SANDSTONE PRECINCT

23-39 BRIDGE STREET
SYDNEY NSW, 2000

**PROPOSED PLANS - LANDS BUILDING -
LOWER GROUND, EDUCATION BUILDING -
BASEMENT 01**

FOR APPROVAL

PROPOSED PLANS - LANDS BUILDING - LEVEL 03, EDUCATION BUILDING - LEVEL 02

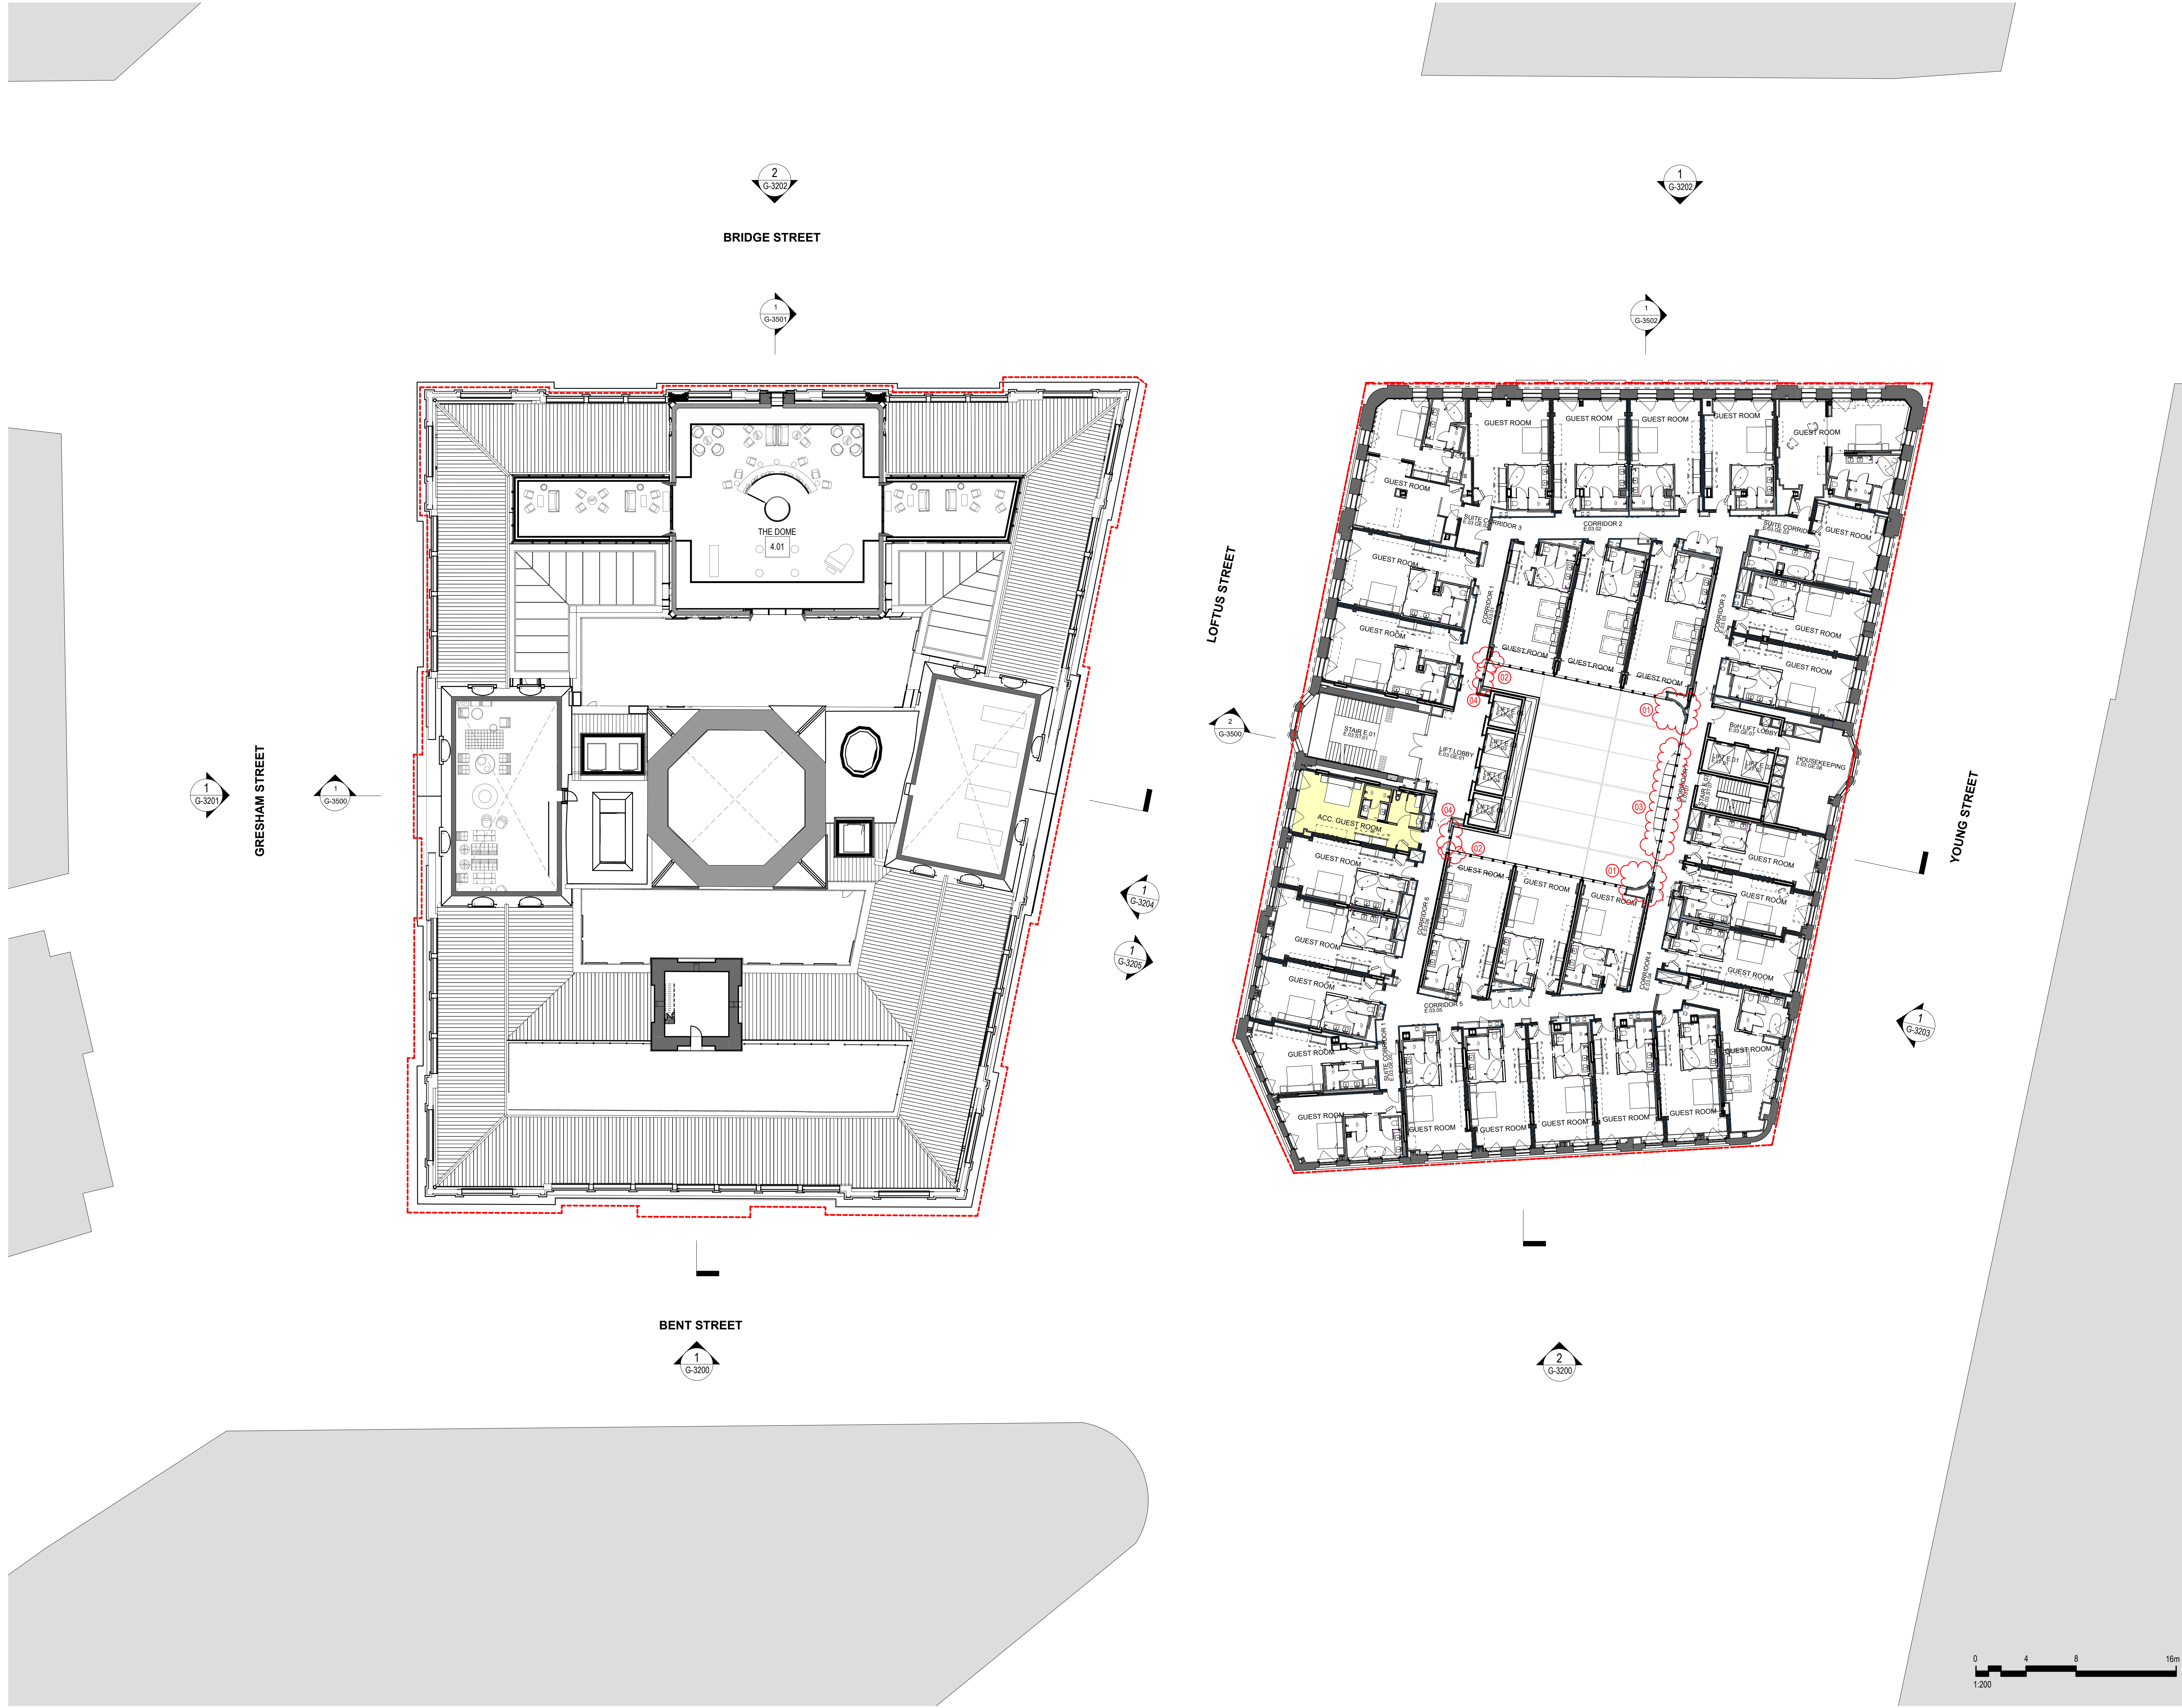
01 BACKPAN ADDED TO GLASS PANELS

02 CURVED GLASS CHANGED TO 1500MM RADIUS

03 CURVED GLASS REMOVED

04 AWNING REDUCED IN WIDTH

TITLE
PROPOSED PLANS - LANDS BUILDING - LEVEL 04, EDUCATION BUILDING - LEVEL 03

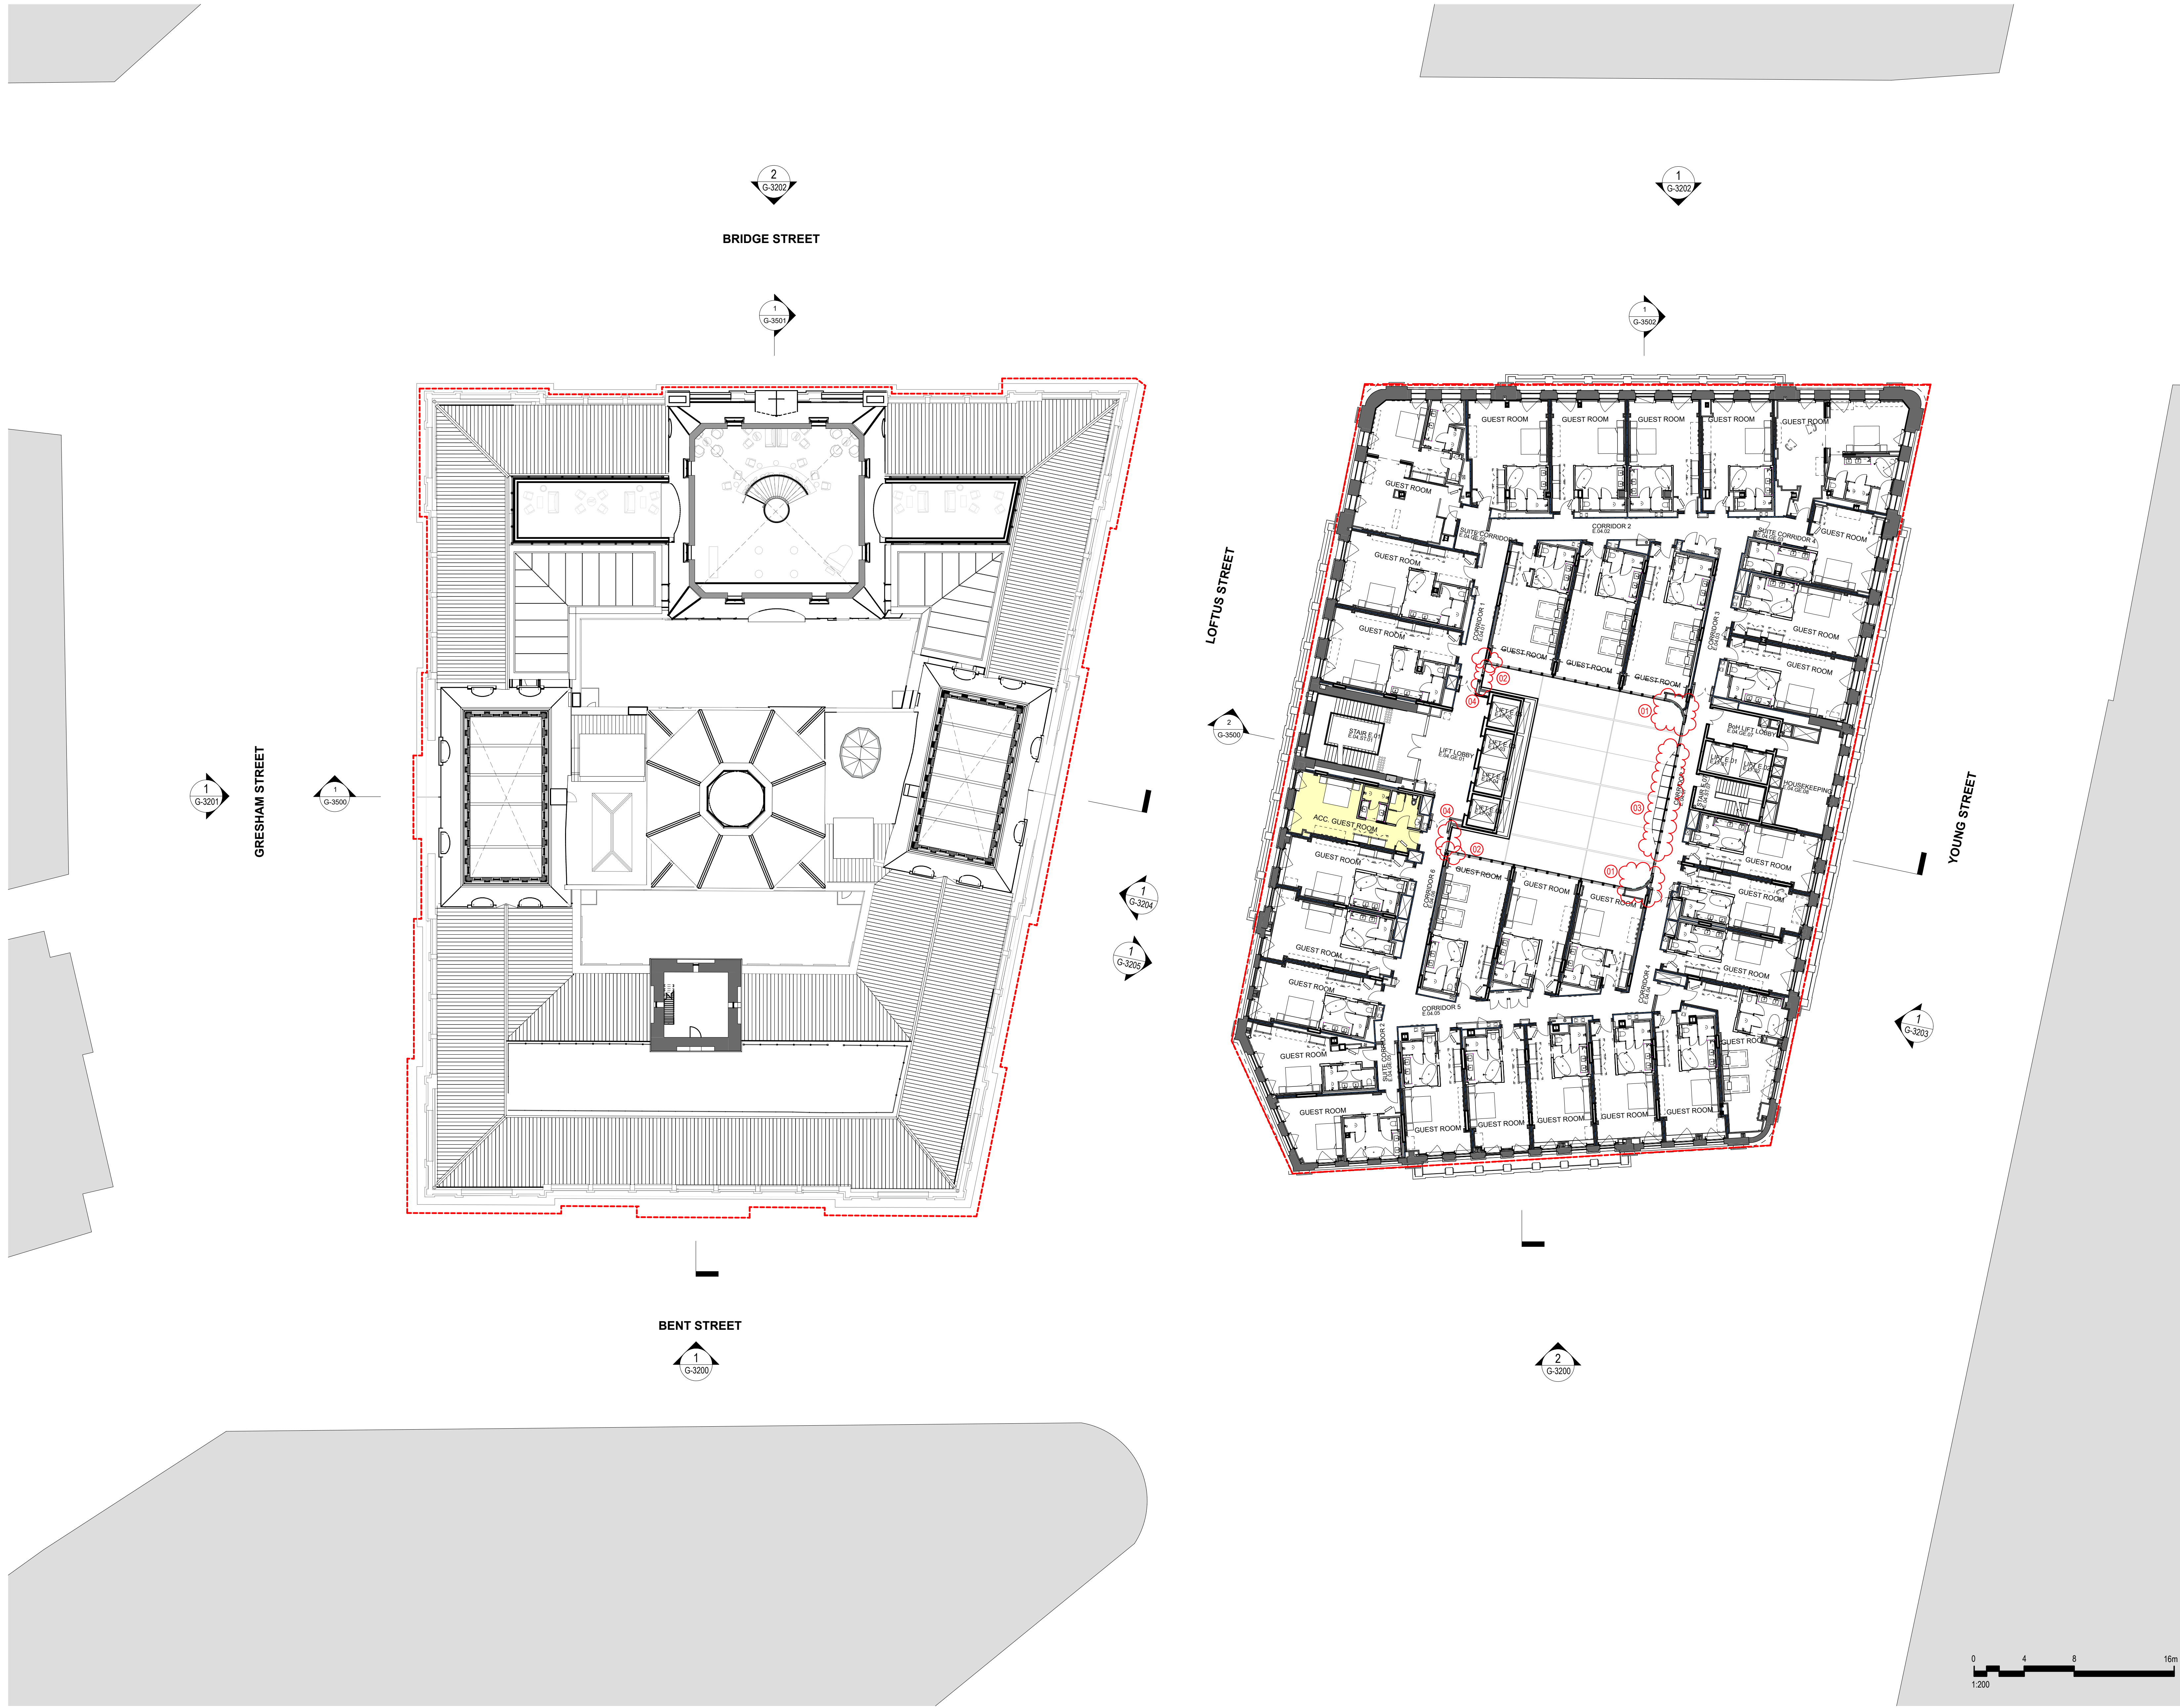
- 01 CURVED GLASS CHANGED TO 1500MM RADIUS
- 02 CURVED GLASS REMOVED
- 03 AWNING REDUCED IN WIDTH
- 04 BACKSPAN ADDED TO GLASS PANELS

TITLE
PROPOSED PLANS - LANDS BUILDING - LEVEL 05, EDUCATION BUILDING - LEVEL 04

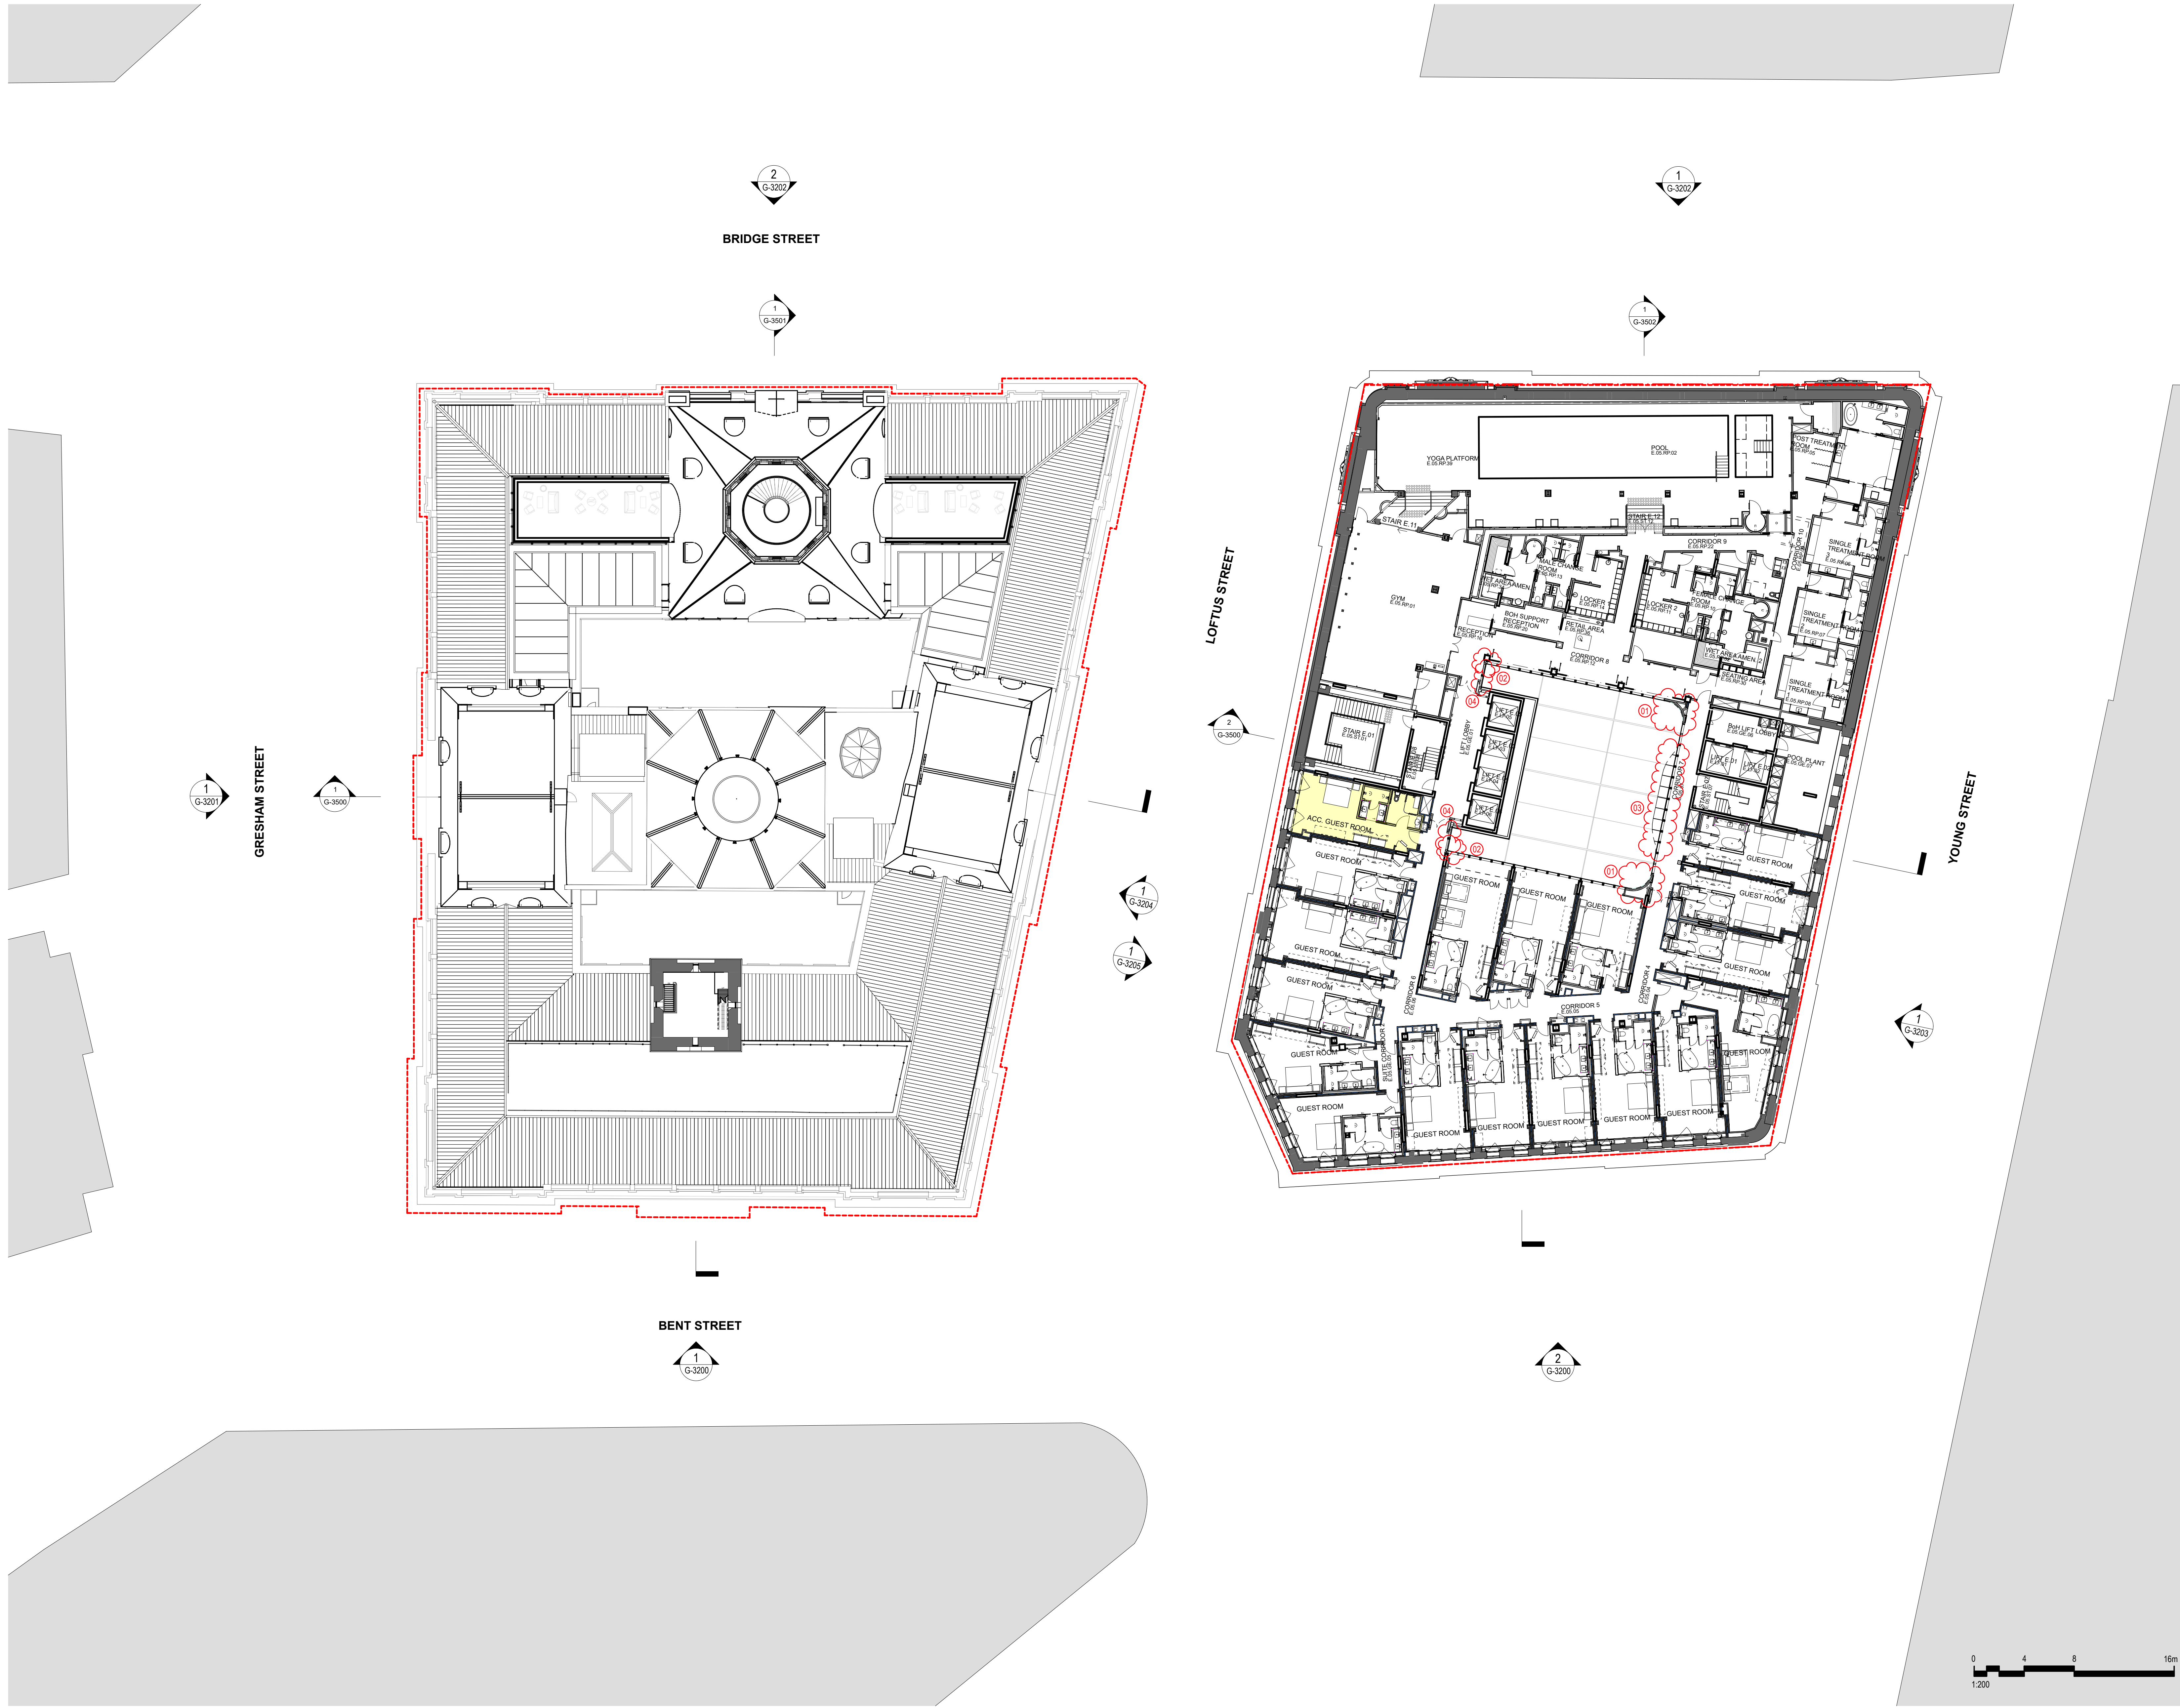
- 01 CURVED GLASS CHANGED TO 1500MM RADIUS
- 02 CURVED GLASS REMOVED
- 03 AWNING REDUCED IN WIDTH
- 04 BACKPAN ADDED TO GLASS PANELS
